## **Supplement to the proposal for 04 series of amendments to Regulation No. 12**

The text reproduced below was prepared by the expert from France in order to extend the scope of the present Regulation to all kinds of power train systems above a certain working voltage level. The modifications to the existing text of the Regulation R 12 are based on informal document No. GRSP- 46-04, distributed during the forty sixth session of the Working Party on Passive Safety (GRSP) and discussions made at the 3<sup>rd</sup> EVPC adhoc group meeting held in Bonn, 11-12 march 2010. This informal document supersedes document ECE/TRANS/WP.29/GRSP/2010/19 distributed as an official document for the forty-seventh session of the Working Party on Passive Safety (GRSP). The modifications to the existing text of Regulation No. 12 are originally marked in bold or strikethrough characters and the modifications resulting from the EVPC meeting are highlighted in grey colour.

**Annex 7 - Test Procedures for the Protection of the occupants of vehicles operating on electrical power from high voltage and electrolyte spillage.**  
~~**Appendix 1 – Protection against direct contacts of parts under voltage”**~

**Figure 1:** Measurement of  $V_b$ ,  $V_1$ ,  $V_2$ ,  $V_3$

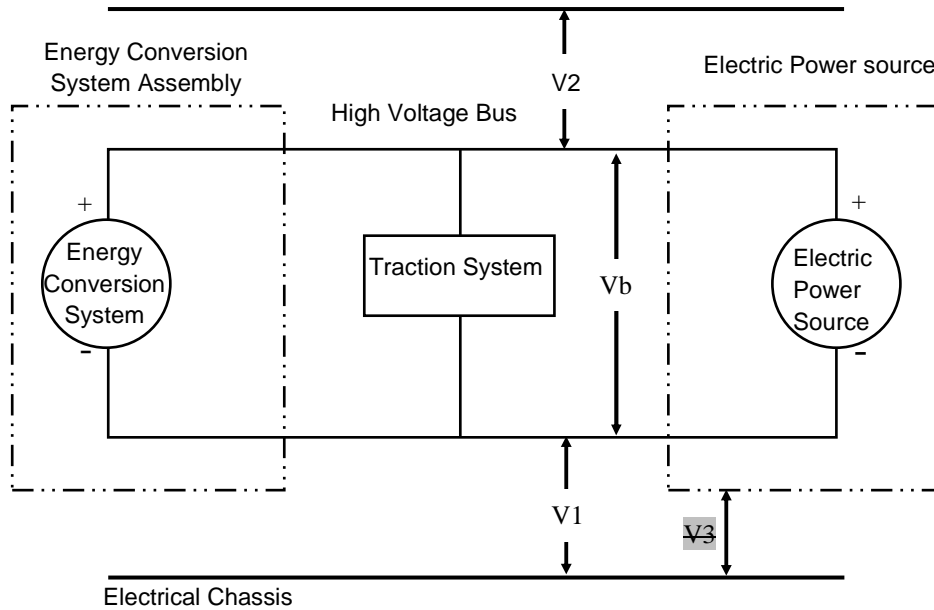
**After the impact crash test, determine the high voltage bus voltages (Vb, V1, V2) (see figure 1). ~~If the RESS has exposed conductive parts,~~**

measure the voltage  $V_3$  between any exposed conductive parts of it and the electrical chassis.

The measurement shall be made at 5 seconds after the impact.

The voltage measurement shall be made not earlier than 5 seconds but not later than 60 seconds after the impact.

**Figure 2:** E.g. Measurement of high voltage bus energy stored in X-capacitors

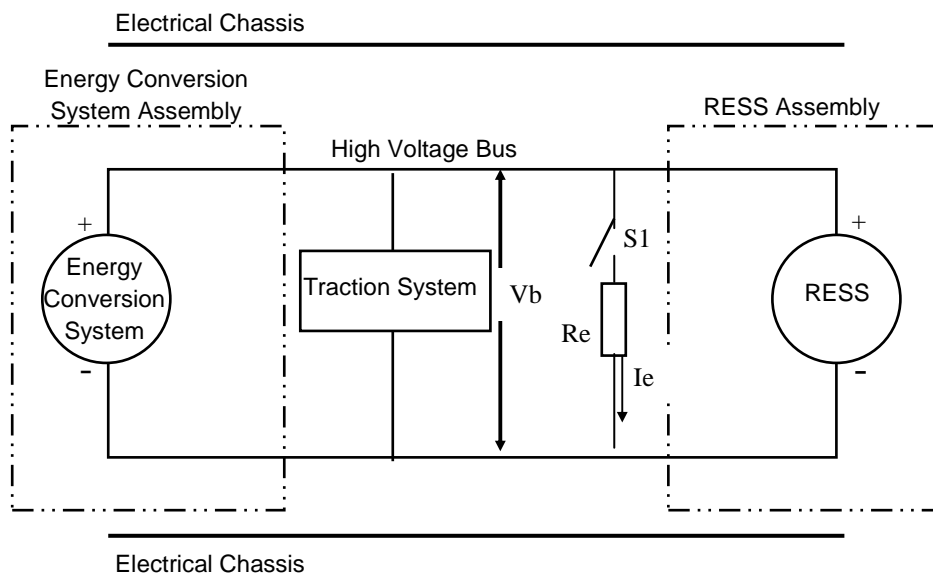
Prior to the impact a switch  $S_1$  and a known discharge resistor  $R_e$  is connected in parallel to the relevant capacitance (ref. figure 2). installed according to figure 2.

Not earlier than 5 seconds and not later than 60 seconds ~~[At 5 seconds]~~ after the impact the switch  $S_1$  shall be is-closed while the voltage  $V_b$  and the current  $I_e$  are is-measured and recorded. The product of the voltage  $V_b$  and the current  $I_e$  shall be is-integrated over the period of time, starting from the moment when the switch  $S_1$  is closed ( $t_c$ ) until the voltage  $V_b$  falls below the high voltage threshold of 30 V AC or 60 V DC ( $t_h$ ). The resulting integration equals in the total energy (TE) in joules:

**Figure 3): Measurement of V'1**

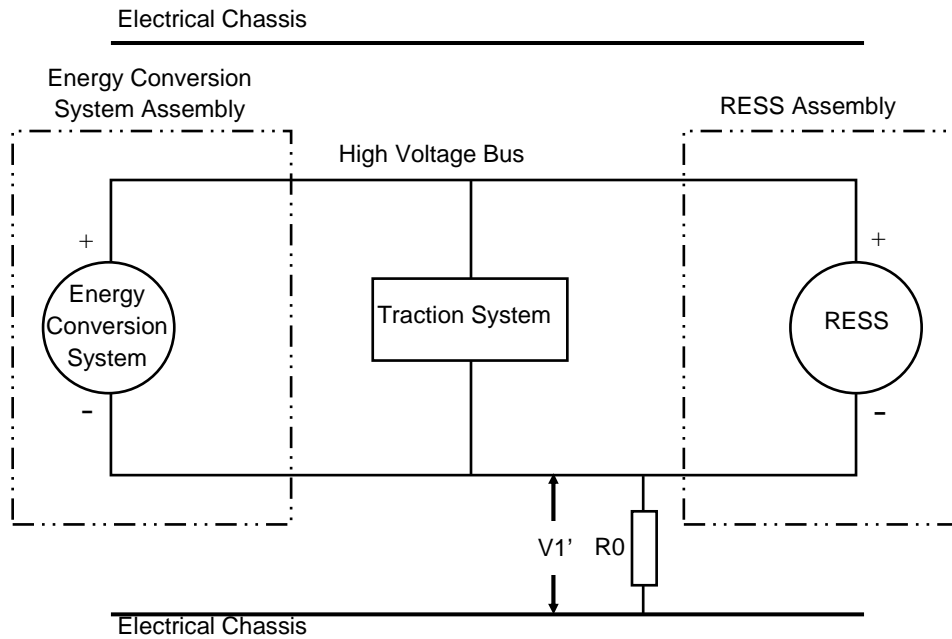
If V1 is greater than or equal to V2, insert a standard known resistance (Ro) between the negative side of the high voltage bus and the electrical chassis. With Ro installed, measure the voltage (V1') between the negative side of the high voltage bus and the vehicle electrical chassis (see

**Figure 3). Calculate the isolation resistance (Ri) according to the formula shown below.**

**Divide the result Ri, which is the this electrical isolation resistance value (in Ω) by the working voltage of the high voltage bus (in volts Volt).**

**Figure 4: Measurement of  $V2'$**

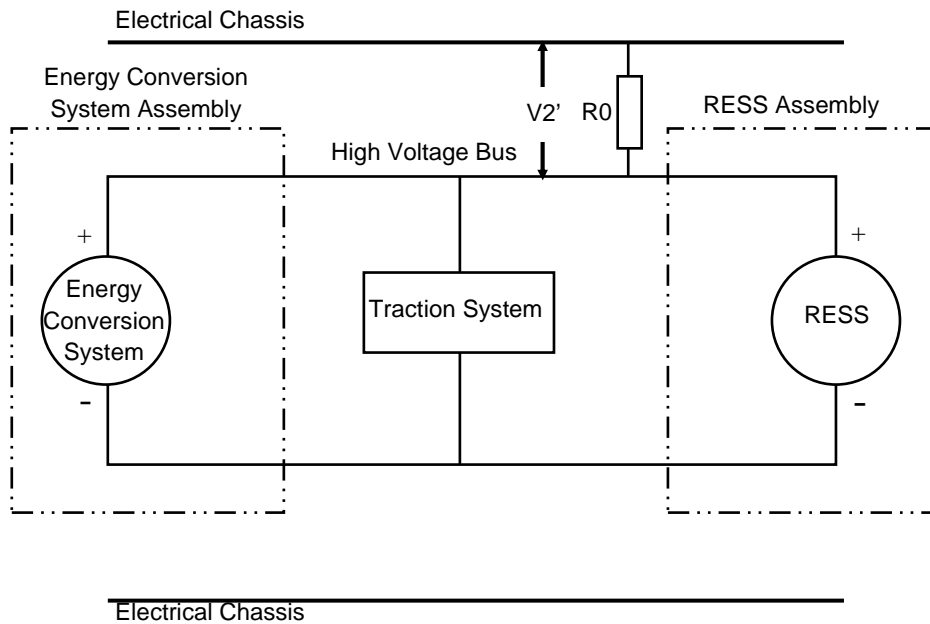
**If V2 is greater than V1, insert a standard known resistance (Ro) between the positive side of the high voltage bus and the electrical chassis. With Ro installed, measure the voltage (V2') between the positive side of the high voltage bus and the electrical chassis (see figure 4).**

**Calculate the isolation resistance (Ri) according to the formula shown below. Divide the result, which is the this electrical isolation value (in Ω) by the working voltage of the high voltage bus (in volts).**

**Divide the result Ri, which is the electrical isolation resistance value (in Ω) by the working voltage of the high voltage bus (Volt).**

**Figure 1: Jointed test finger**

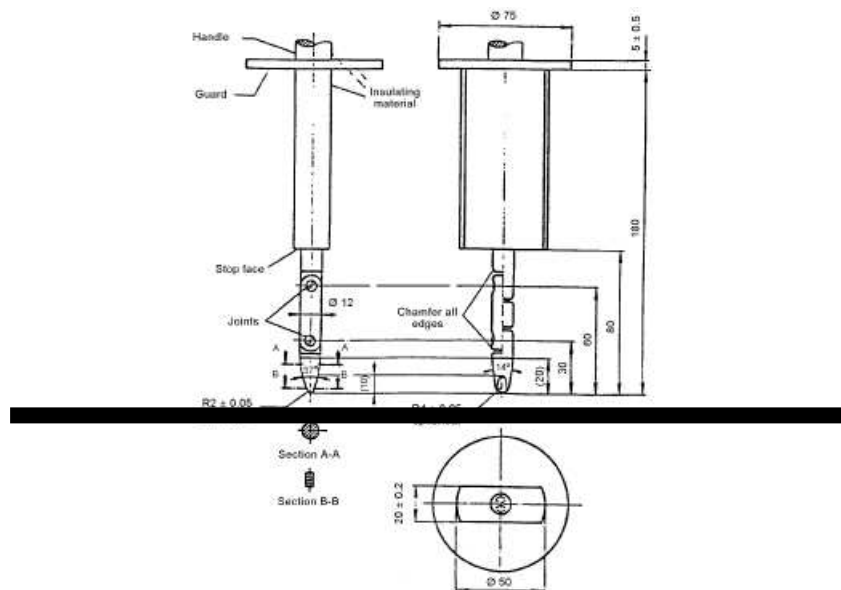
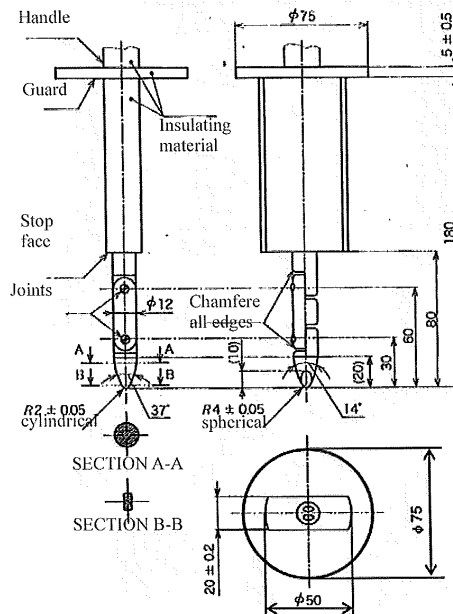
The Jointed Test Finger ~~access probe~~ described in Appendix 1 figure 1 is ~~pushed against~~ shall be inserted into any gaps or openings of the ~~[original]~~ physical protection with a ~~the~~ test force of  $10\text{ N} \pm 10\text{ per cent}$  for electrical safety assessment. ~~If partial or full penetration it partly or fully penetrates into the [original] physical protection by the Jointed Test Finger occurs, it is the~~ Jointed Test Finger shall be placed in every possible position as specified below.

Starting from the straight position, both joints of the test finger shall be rotated progressively ~~successively bent~~ through an angle of up to 90 degrees with respect to the axis of the adjoining section of the finger and shall be placed in every possible position.

The requirements of paragraph 5.5.1.3 shall be considered to be met if the Jointed Test Finger ~~access probe~~ described in Appendix 1, figure 1 ~~shall not~~ is unable to contact ~~touch~~ high voltage live parts.
